## STAFF REPORT COMMUNITY DEVELOPMENT DEPARTMENT

SUBJECT: FP-2020-0007  
Sky Mesa Highlands No. 1

Final plat consisting of 82 buildable lots and 13 common lots on 32.92 acres of land in the R-4 zoning district.

D. Common Driveway Exhibit

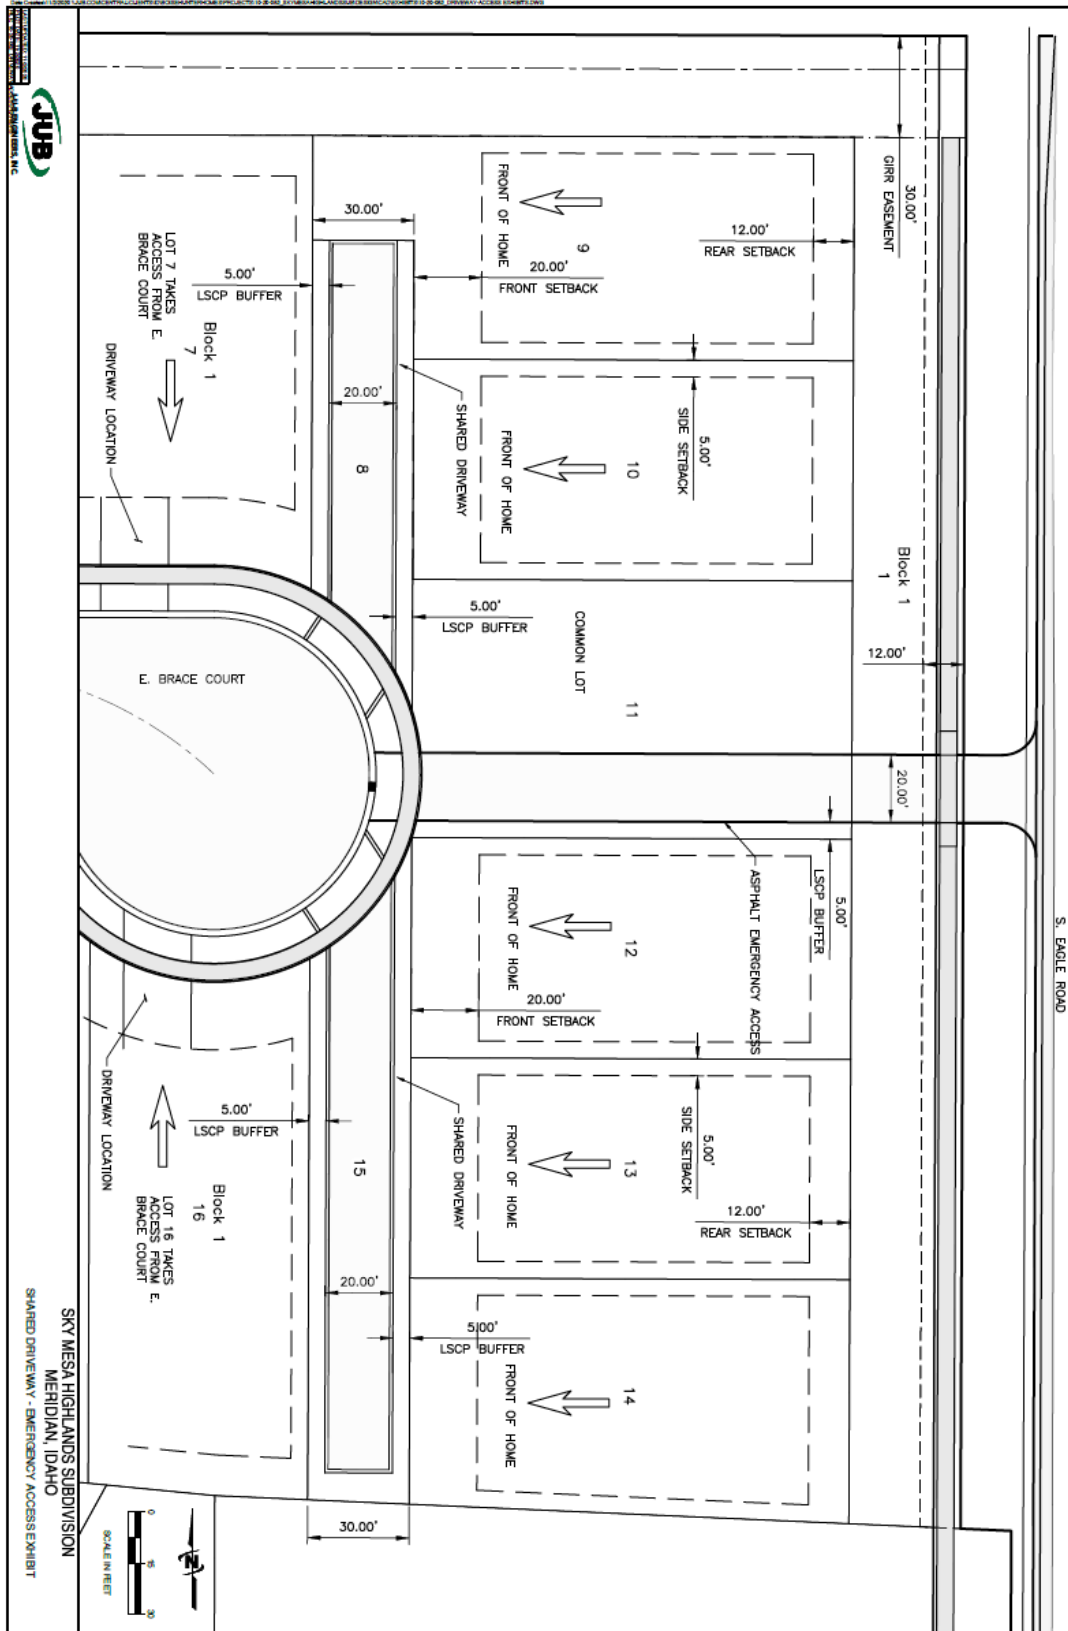
6. Construction of the common driveways on Lots 8 and 15, Block 1 shall comply with the standards listed in UDC 11-6C-3D and with the exhibit in Section V.D.
